-1	,		,	, -				
	ADEO	WATER	DIVISION INSPECTION REPORT						
AULU			AFIN: 67-00023 PERMIT #: AR002173		733		DATE: 1/4/2017		
Α	RKANSAS	CC	DUNTY: 67 Sevie	r	PDS #	#: 094792	MEDIA: WN		
	partment of Environmental Quality	GF	PS LAT: 34.02608	1 LONG: -94.3473	354 L	OCATION:	ntrance		
FACILITY INFORMATION			INS	SPEC1	TION INFOR	MATION			
City of DeQueen WWTP				FACILITY TYPE: INSPECTOR ID#: 26294 S - State					
LOCATION: 670 South 9 th Street				FACILITY EVALUATION RATING: INSPECTION TYPE: 2 - Marginal SSO/Collection System					
De	Queen			DATE(S): ENT	RY TIME:	EXIT TIME:	PERMIT EFFECTIVE DATE:		
	RESPONSIBLE OFFIC	CIAI			:00	16:00	11/1/2013		
	ET TITLE Chael Sims / WW Superintendent			1/5/2017 13:00 16:30 PERMIT EXPIRATION DATE: 10/31/2018					
COMI	PANY:	-		FAYETTEVILLE SHALE RELATED: N					
	y of DeQueen ng address:			FAYETTEVILLE S	SHALI	E VIOLATIO	NS: N		
_	Box 730					ION PARTI	CIPANTS		
	STATE, ZIP: Queen AR 71832			Mike Sims, WW		intendent

RE: City of DeQueen SSO Inspection

Subject: De Queen WWTP inspection response AR0021733, ARR00C398

Photographer	r: Red Smith	Date:	1/4/2017	Time:	1516
Witness: Mil	ke Sims / WW Superintendent			Photo #:	4

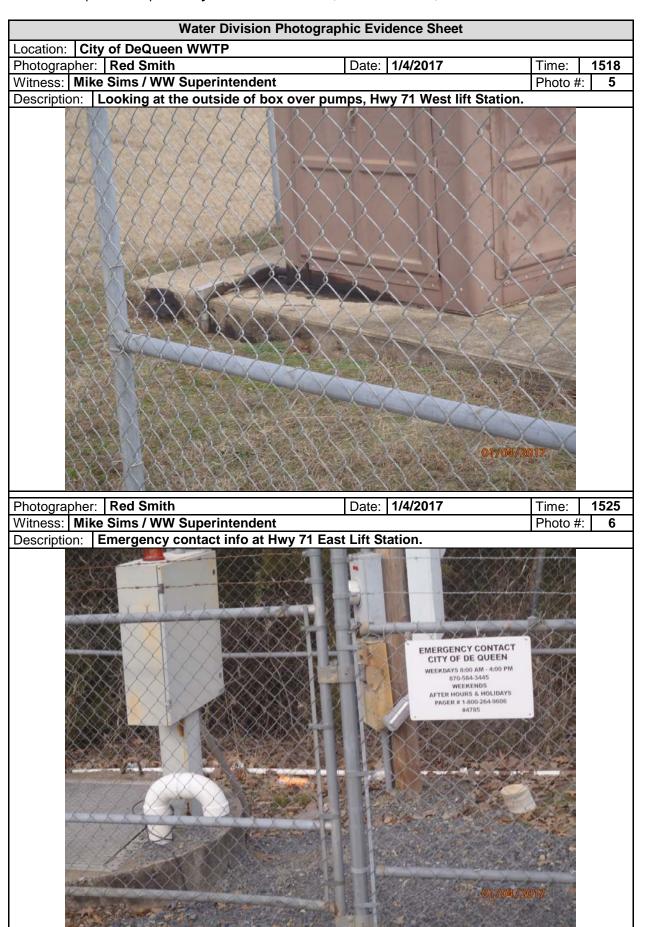
Description: Oil Leak on north side of box at Hwy 71 West Station.

Water Division Photographic Evidence Sheet							
Location:	City	of DeQueen WWTP					
Photographer: Red Smith Date: 1/4/2017 Time: 1514							
Witness: Mike Sims / WW Superintendent					Photo #:	3	
Descriptio	_n . L	Looking at the inside of north side of Hwy 71 West Station. Appears that seals are					
Describing	· · · L	leaking or fluid reservoirs are being overfilled

On January 4 & 5 2017 a compliance evaluation inspection was performed at the City of De Queen Wastewater Plant. In the summary of findings Collection System, it was reported that the Hwy 70 West Lift Station had an oily leak and needed to be cleaned and repaired. In the attach pictures you will see that the inside and outside has been cleaned, also in watching the pumps operate no leaking was seen, in talking to the maintenance staff it was found out that when the oil has been changed some will leak out into floor and not cleaned up properly. In the future all excess oil will be captured for disposal and I will keep a better watch on the situation.
